ISSUE STATUS
ADDENDUM 1

PROJECT
PALMERS STUD

TITLE
SECTIONS PROPOSED

A302

C-C

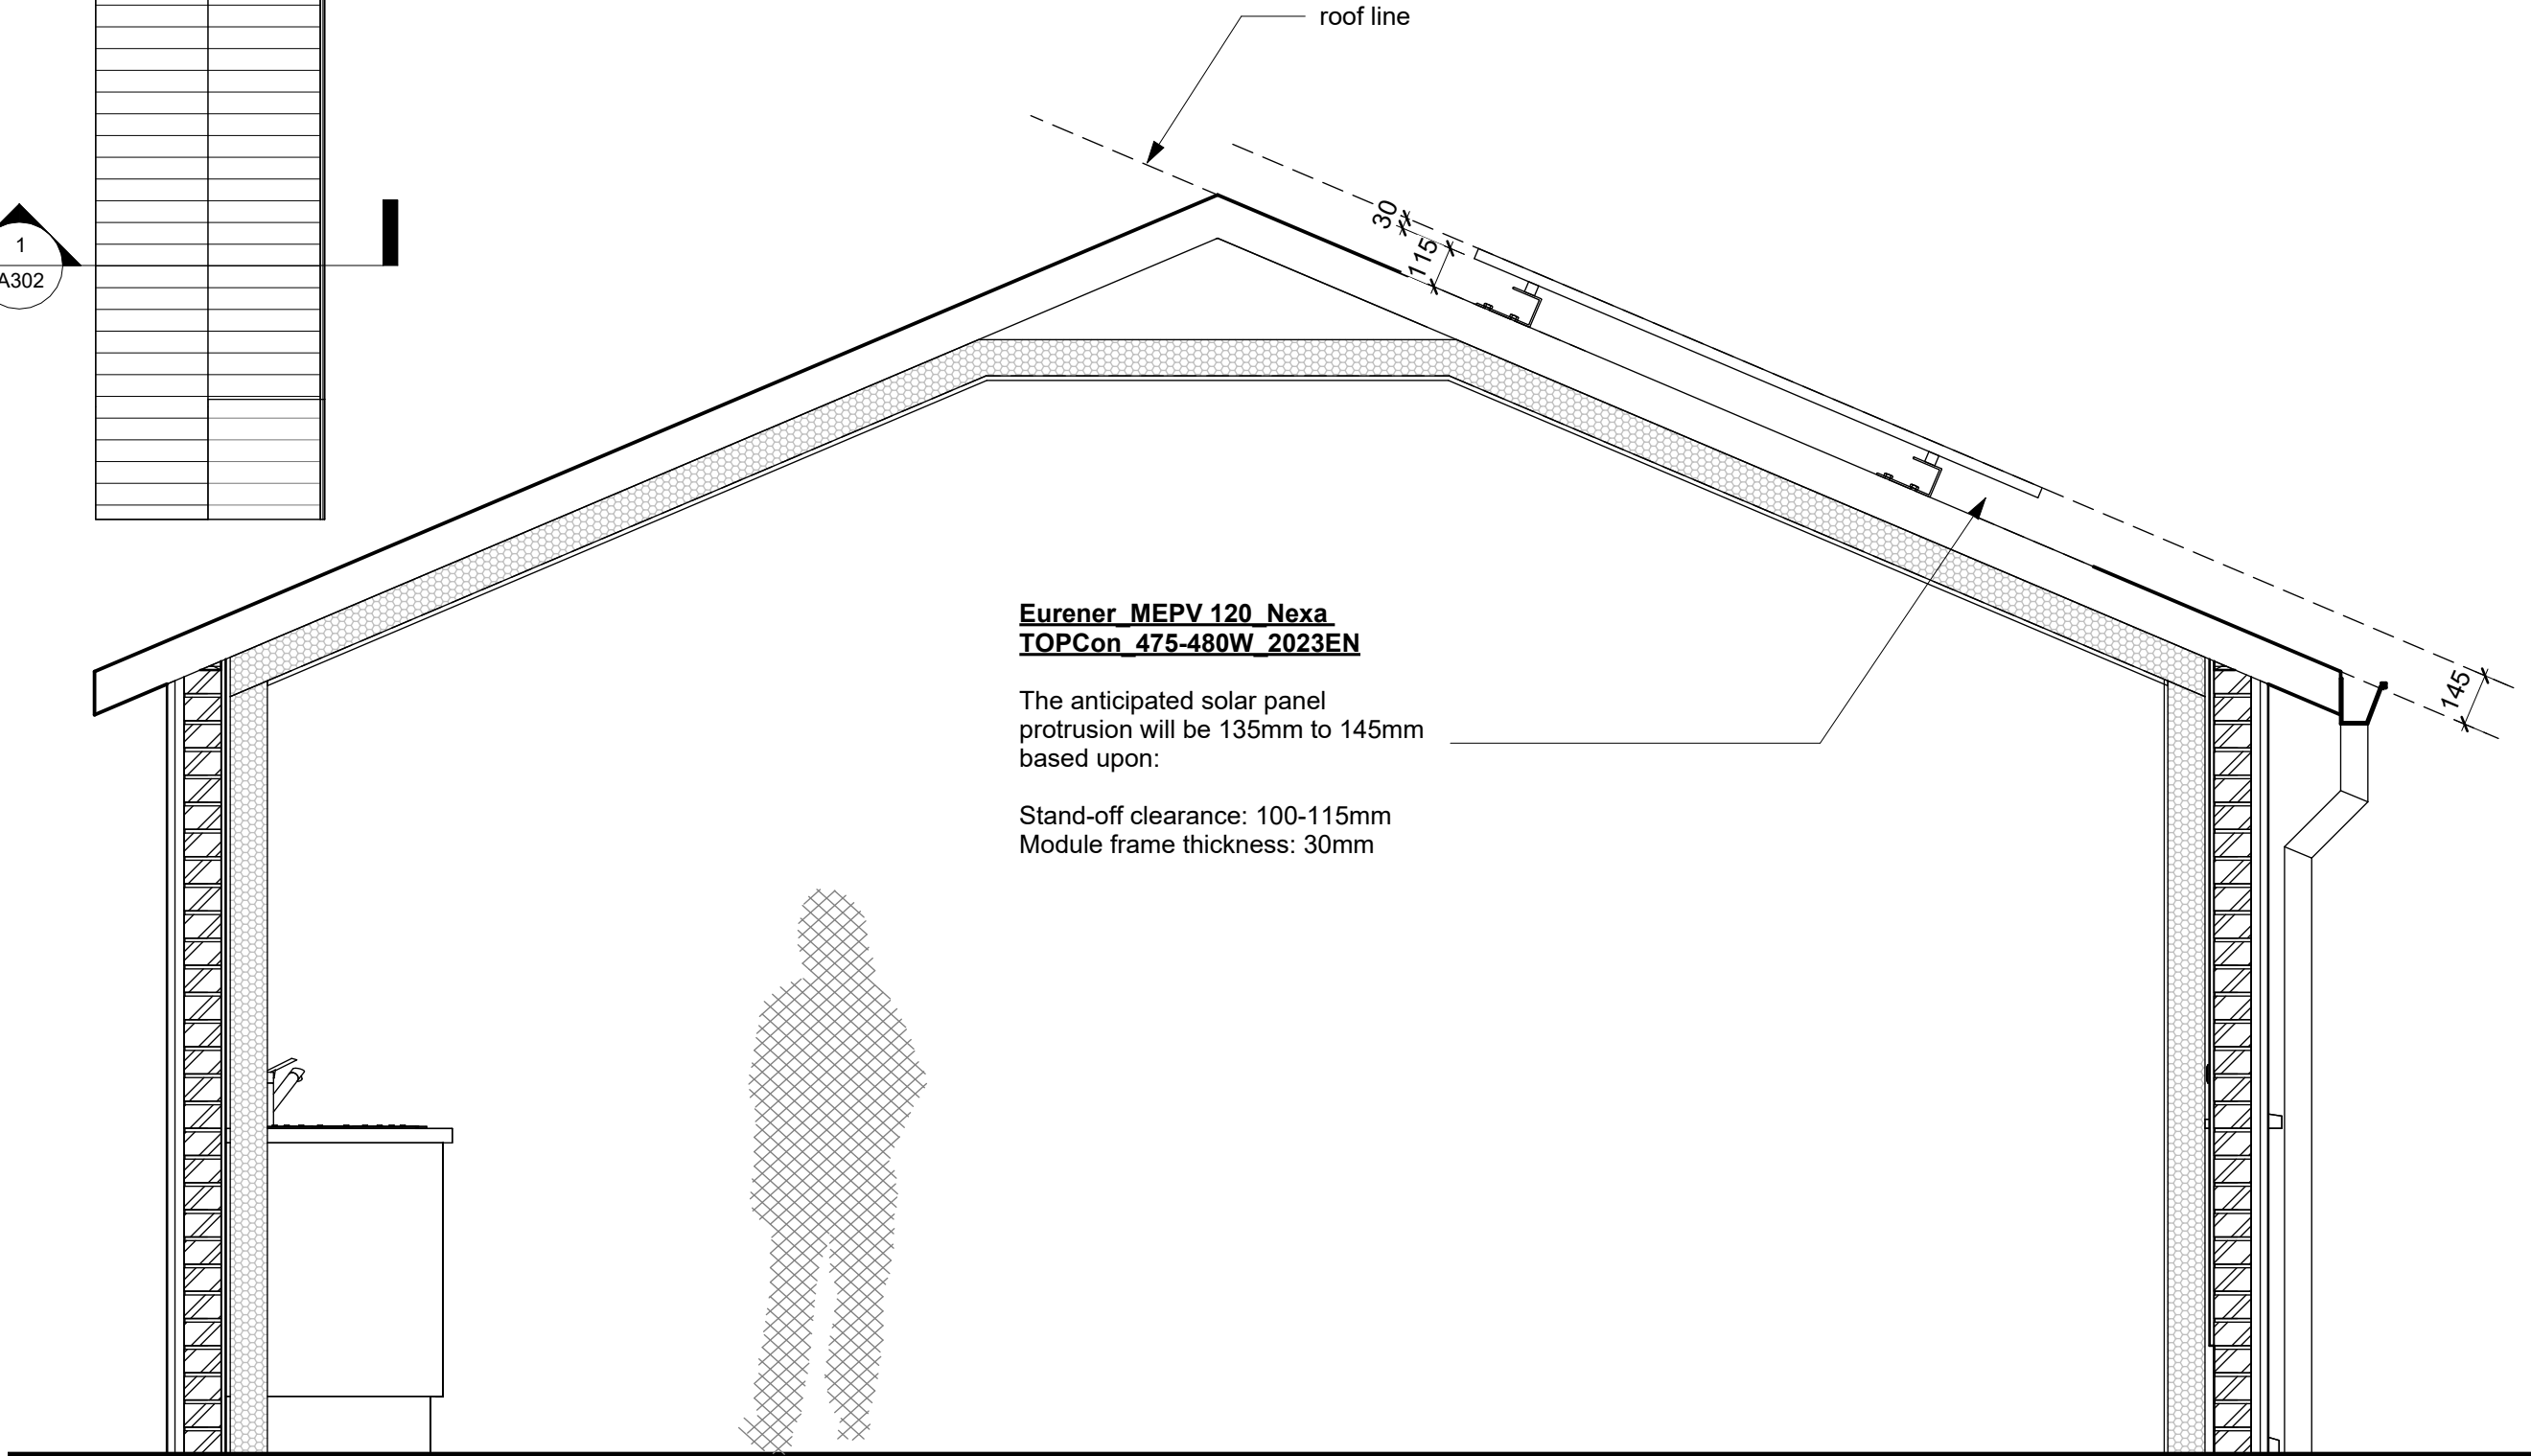
The anticipated solar panel
protrusion will be 135mm to 145mm
based upon:

Stand-off clearance: 100-115mm
Module frame thickness: 30mm
